To: Norma Castaneda, DOE/RFFO, x4226
From: Tracey Spence, RMRS, x4322
Subject: Proposed Design Change for 881 Hillside French Drain Outfall Pipe

As per your request, possible design changes for the French Drain decommissioning pipeline follow.

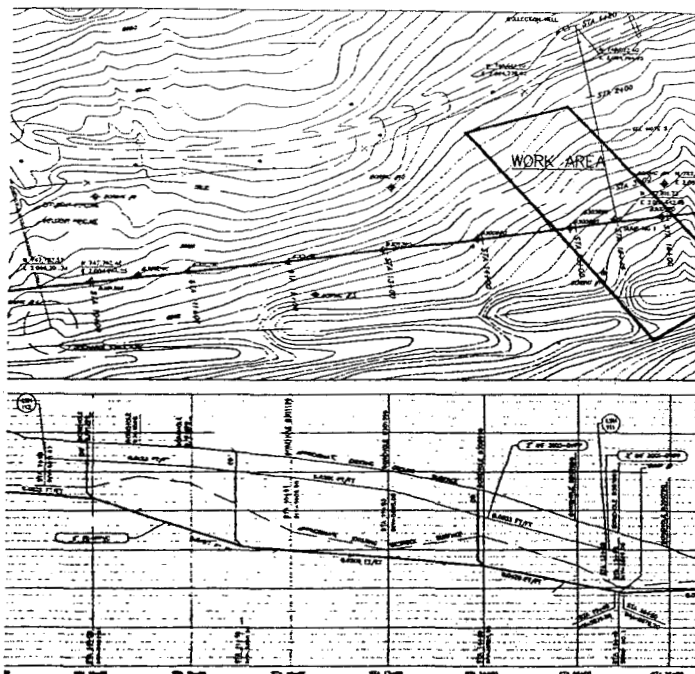
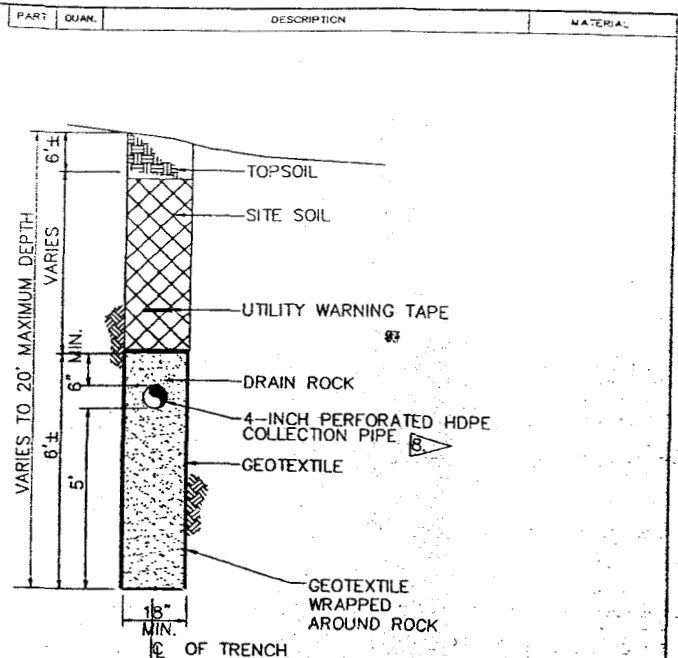
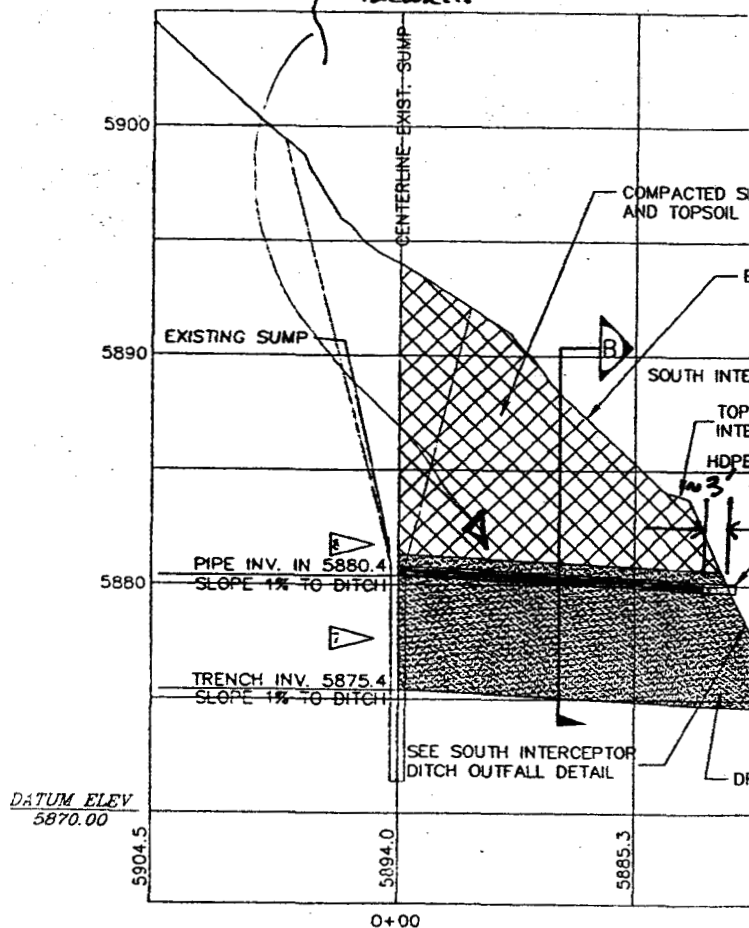
The existing design calls for the French Drain outfall pipe to extend from the South Interceptor Ditch (SID) north side-wall as illustrated on the attached Drawing No. 38548-0150. As designed, the pipeline would be installed in gravel with a geotextile liner and groundwater collected in the French Drain sump would discharge from the outfall pipe directly into the existing riprap embedment of the SID. Please note that the average flow from the pipeline is anticipated to be less than ½-gallon per minute with less than 1-gallon per minute during peak flow.

In order to address the concern with the outfall pipe being exposed in the SID on a long-term basis, it is proposed that the outfall end of the pipe be covered with riprap and/or gravel such that it is still accessible but not exposed at the surface. This would require minimal design change and minimal increase in cost, if any. Operation and flow from the pipeline could still be monitored and, if necessary, sampled and/or serviced. The outfall would appear as a small seep at the SID north side wall.

It is possible to install a shorter length of pipe so the outfall end of the pipeline would remain underground (see changes on drawing in red ink). As such, groundwater would discharge into the lined gravel and riprap embedment and then seep into the SID from the north side wall. This design will require further evaluation to determine long-term effects and impacts on the hillside in the event of peak flow. This configuration would make monitoring the pipeline for satisfactory flow difficult. The outfall would still appear as a seep at the SID north side wall. In the event the SID is remediated in the future, the pipeline location may not be known if it's buried in the side wall.

Consider terminating pi
3 feet of South Inter
sidewall.
